SOUTHWEST AGGREGATE (RESERVOIR) TO CITY OF CAPE CORAL (GATOR SLOUGH) 36" RAW WATER PIPE LINE

NO.	DESCRIPTION	DATE
1	ADDENDUM 1	07/25

PLAN AND PROFILE (GATOR SLOUGH)

SHEET NUMBER
6.34

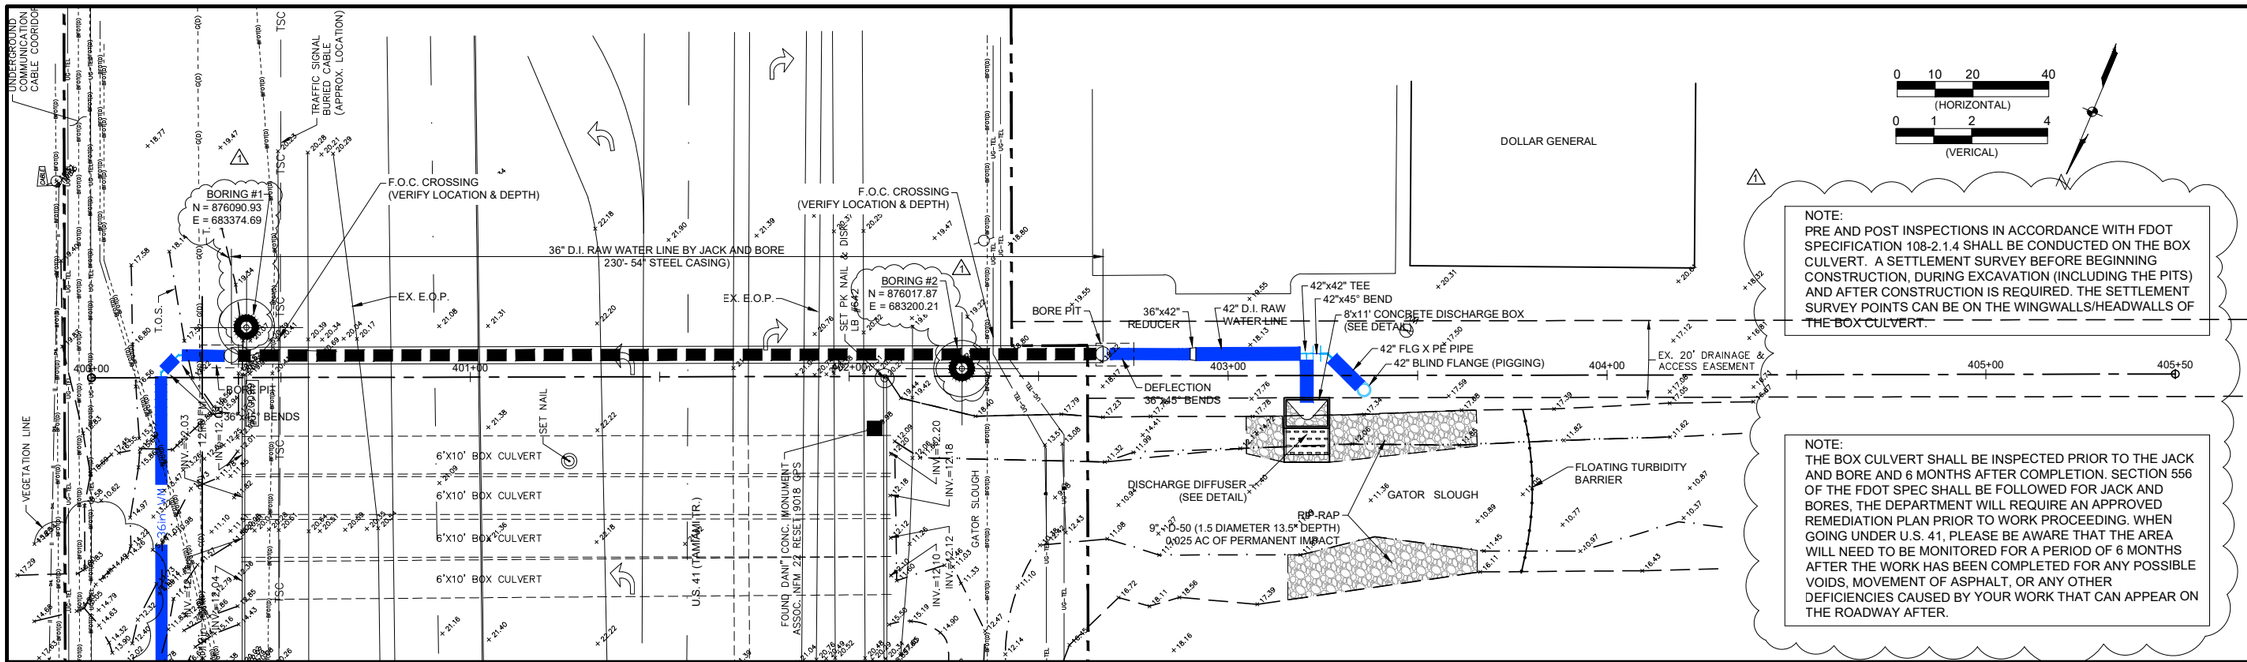
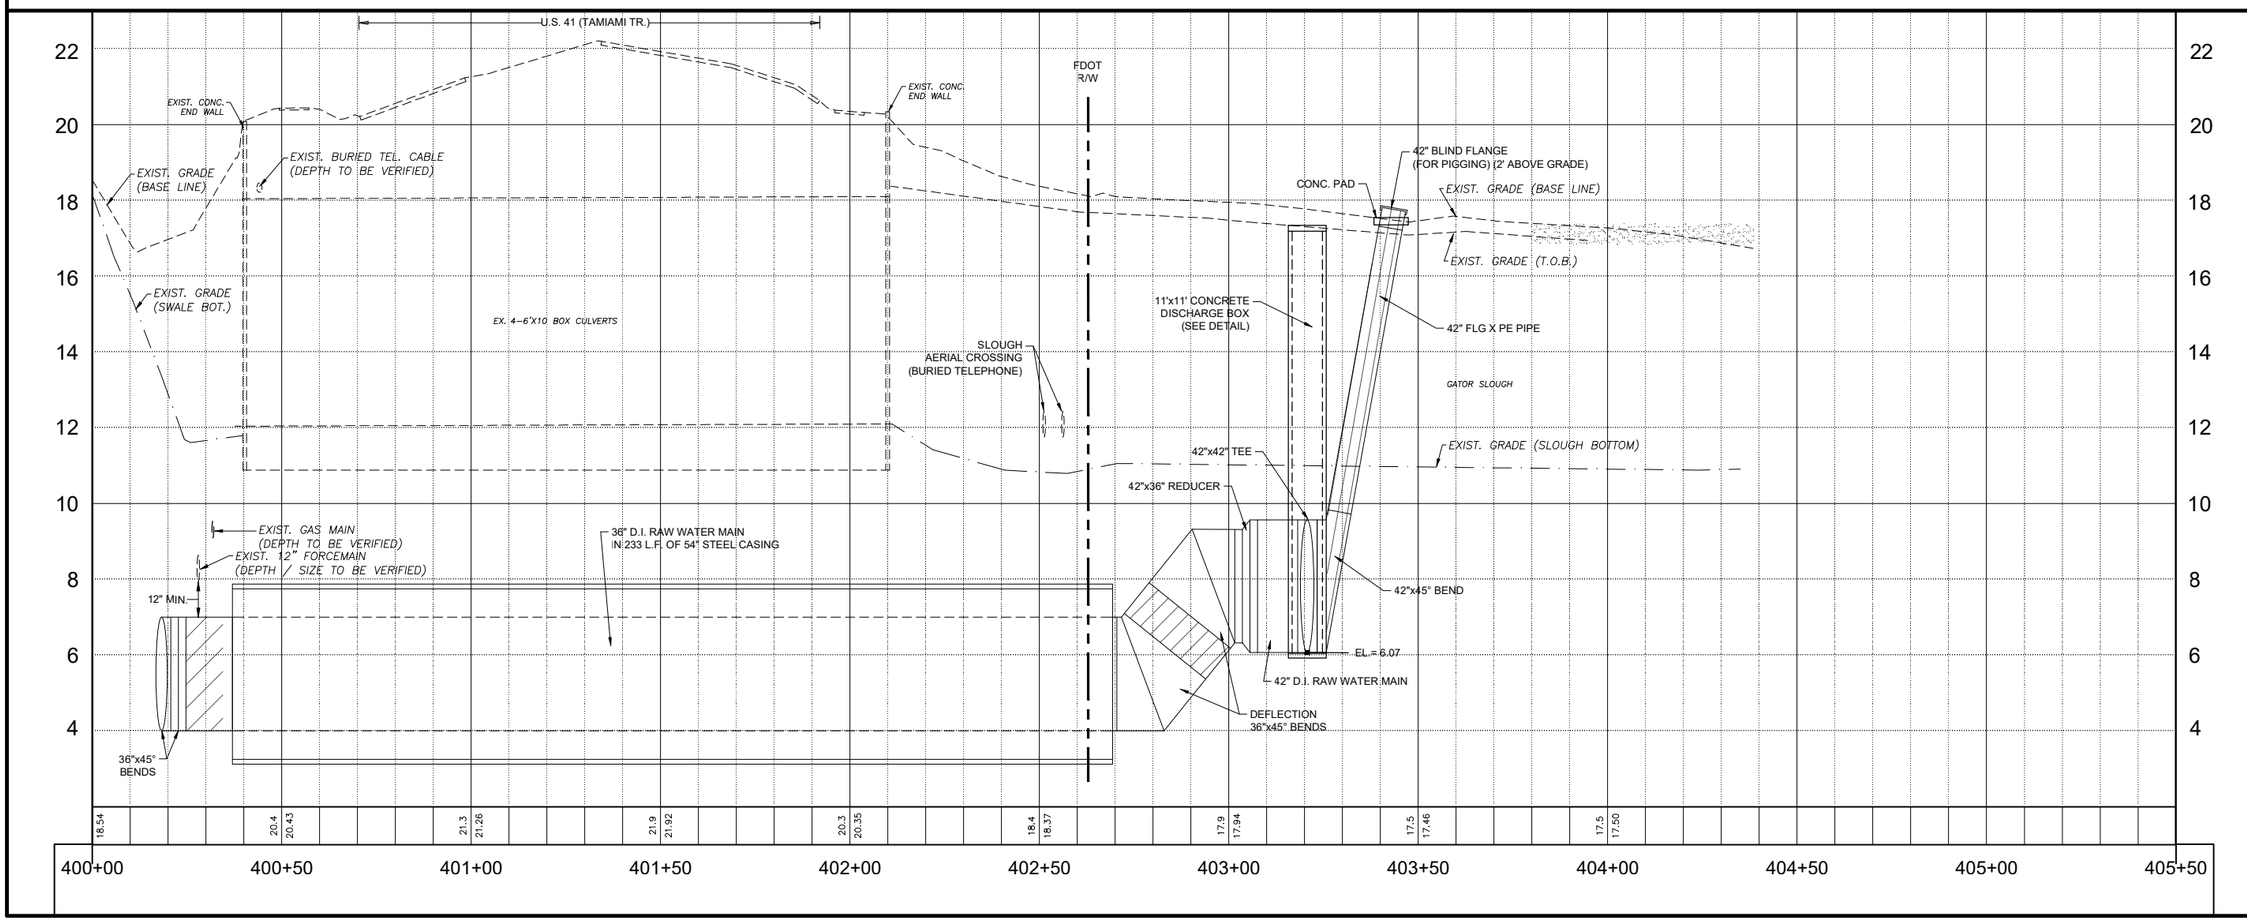
NOTE:
PRE AND POST INSPECTIONS IN ACCORDANCE WITH FDOT SPECIFICATION 108-2.1.4 SHALL BE CONDUCTED ON THE BOX CULVERT. A SETTLEMENT SURVEY BEFORE BEGINNING CONSTRUCTION, DURING EXCAVATION (INCLUDING THE PITS) AND AFTER CONSTRUCTION IS REQUIRED. THE SETTLEMENT SURVEY POINTS CAN BE ON THE WINGWALLS/HEADWALLS OF THE BOX CULVERT.

NOTE:
THE BOX CULVERT SHALL BE INSPECTED PRIOR TO THE JACK AND BORE AND 6 MONTHS AFTER COMPLETION. SECTION 556 OF THE FDOT SPEC SHALL BE FOLLOWED FOR JACK AND BORES, THE DEPARTMENT WILL REQUIRE AN APPROVED REMEDIATION PLAN PRIOR TO WORK PROCEEDING. WHEN GOING UNDER U.S. 41, PLEASE BE AWARE THAT THE AREA WILL NEED TO BE MONITORED FOR A PERIOD OF 6 MONTHS AFTER THE WORK HAS BEEN COMPLETED FOR ANY POSSIBLE VOIDS, MOVEMENT OF ASPHALT, OR ANY OTHER DEFICIENCIES CAUSED BY YOUR WORK THAT CAN APPEAR ON THE ROADWAY AFTER.
